## **ADDENDUM #1**

Date: October 20, 2017

**KENWORTH SALES COMPANY, INC.  
ONTARIO, OREGON  
NEW BUILDING ADDITION**

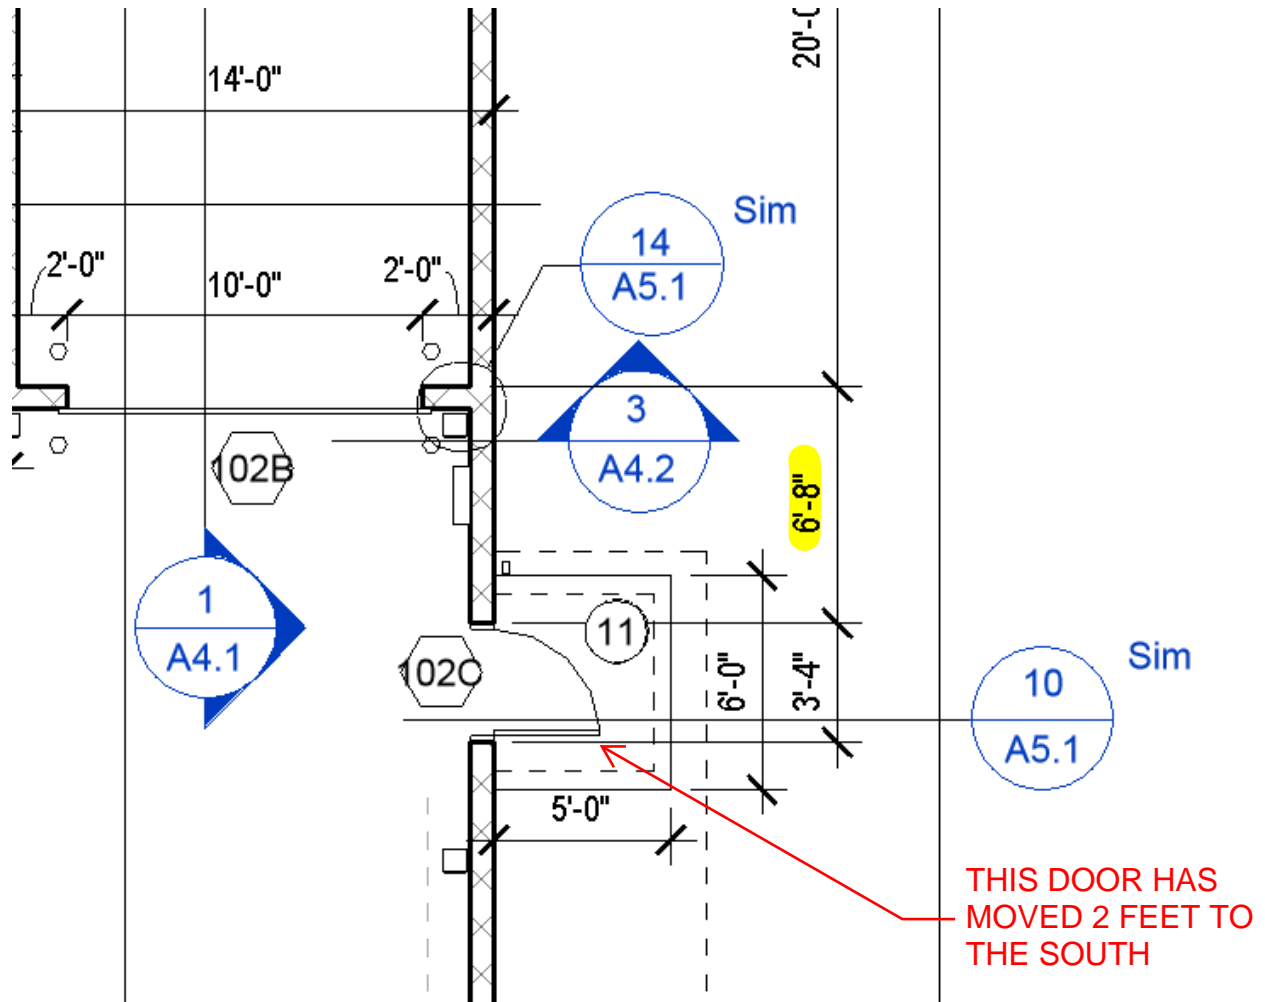
1. Connect the 3/4" cold water line to the existing 1/2" (or larger) cold water line at the ceiling near the existing sink and run in ceiling space as shown to new addition. Core drill through existing concrete block walls as required to run new line. Remove and replace ceiling materials as required to install new water line.

SHEET TITLE:  
Door 102C Revised Location

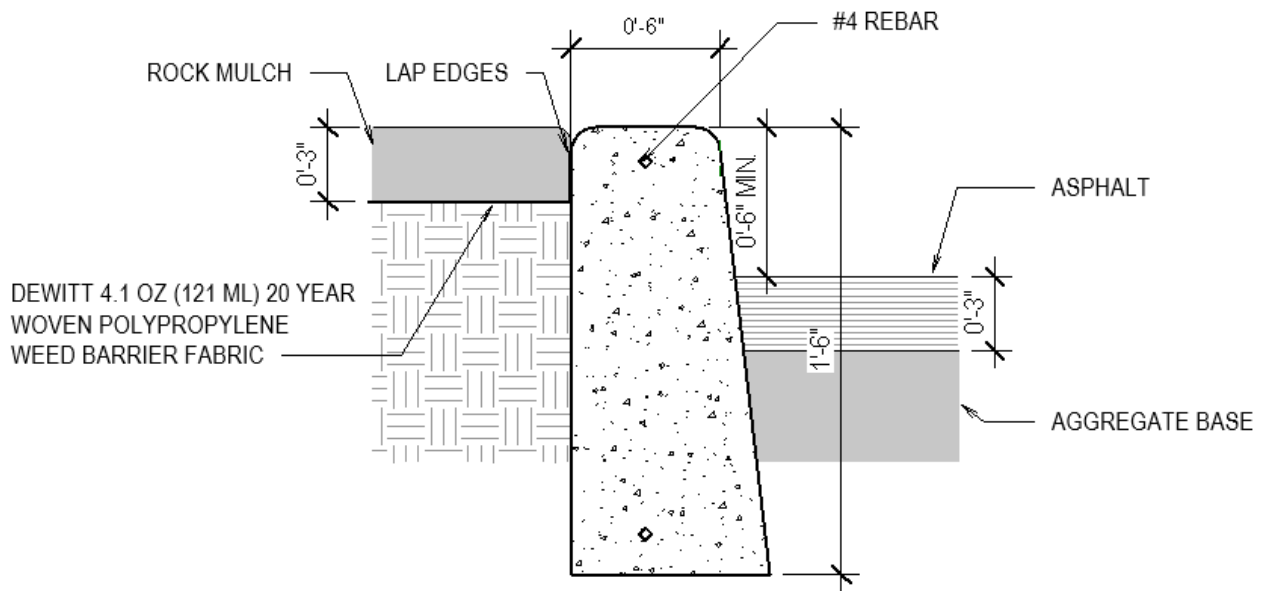
1. Sheets SD1.1 and A1.1 - the fire hydrant location is incorrectly shown on these sheets - see sheet C1 for correct fire hydrant location.
2. Sheet A1.1 - see attached AD1.0 for revised location of door 102C.
3. Sheet A5.1 Detail 11 - replaced by attached AD1.1. See also C4 Detail 11.

MECHANICAL PLAN AND SCHEDULES

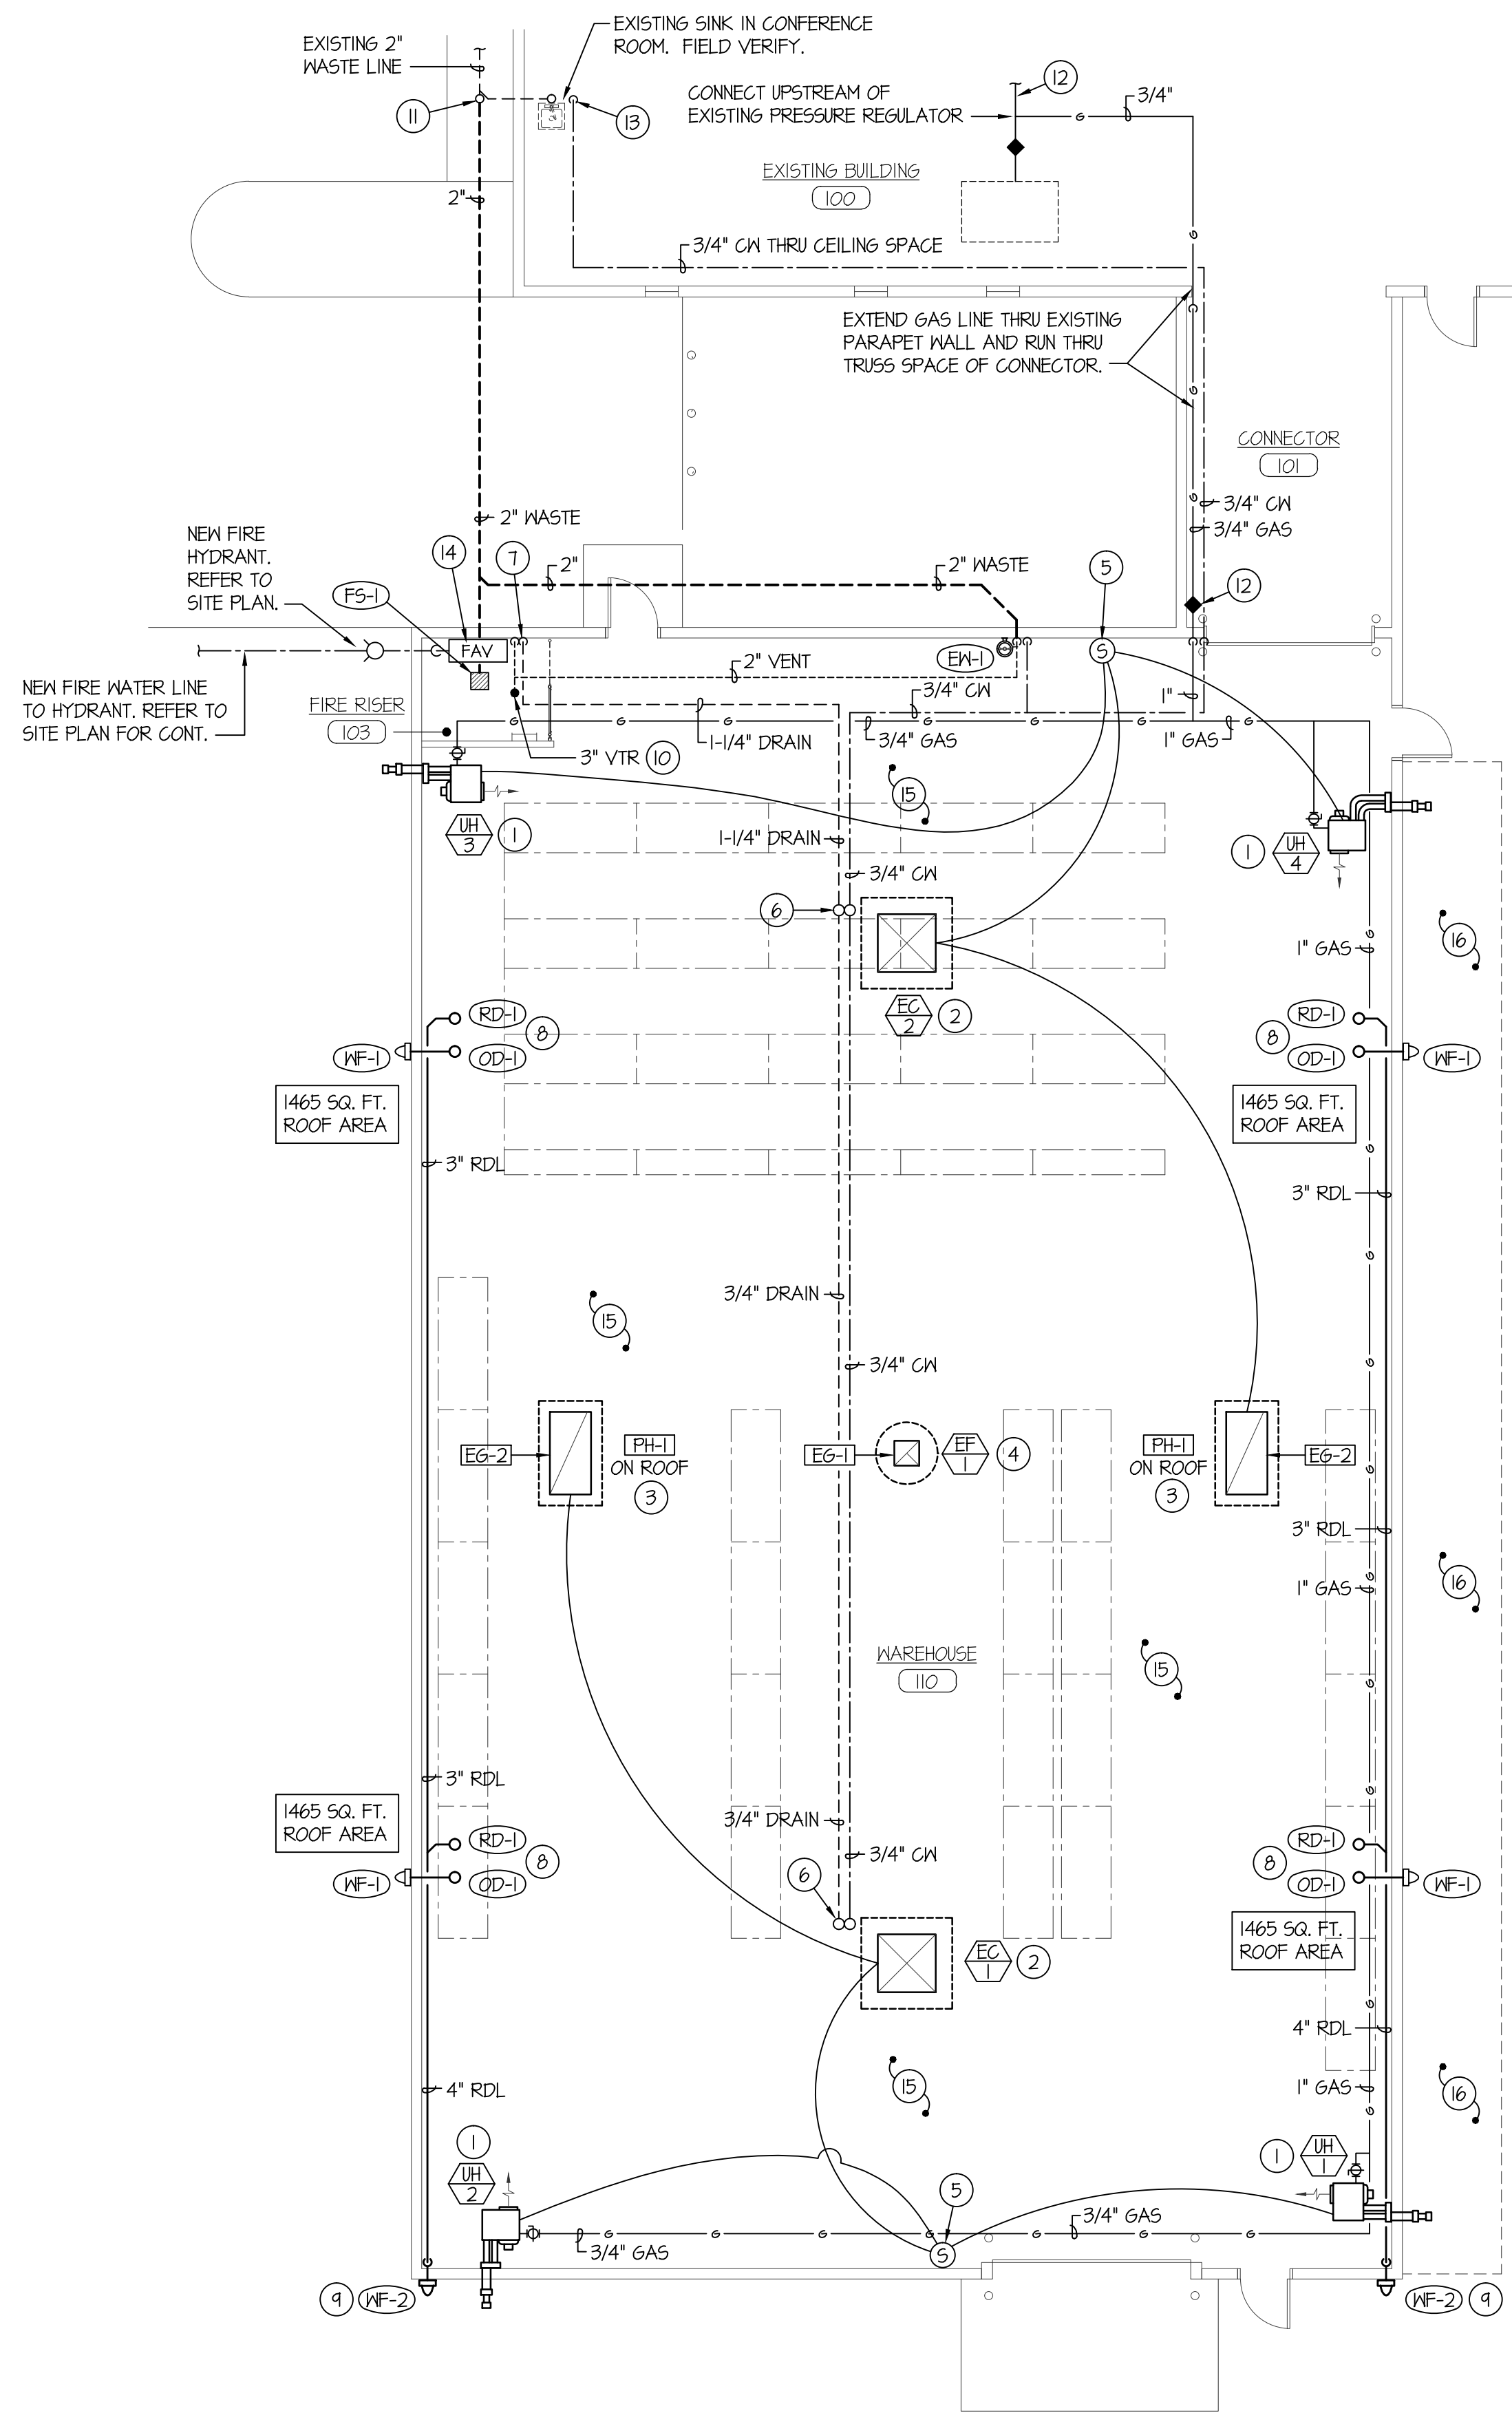
1. Sheet M1.1 has been replaced - see attached.
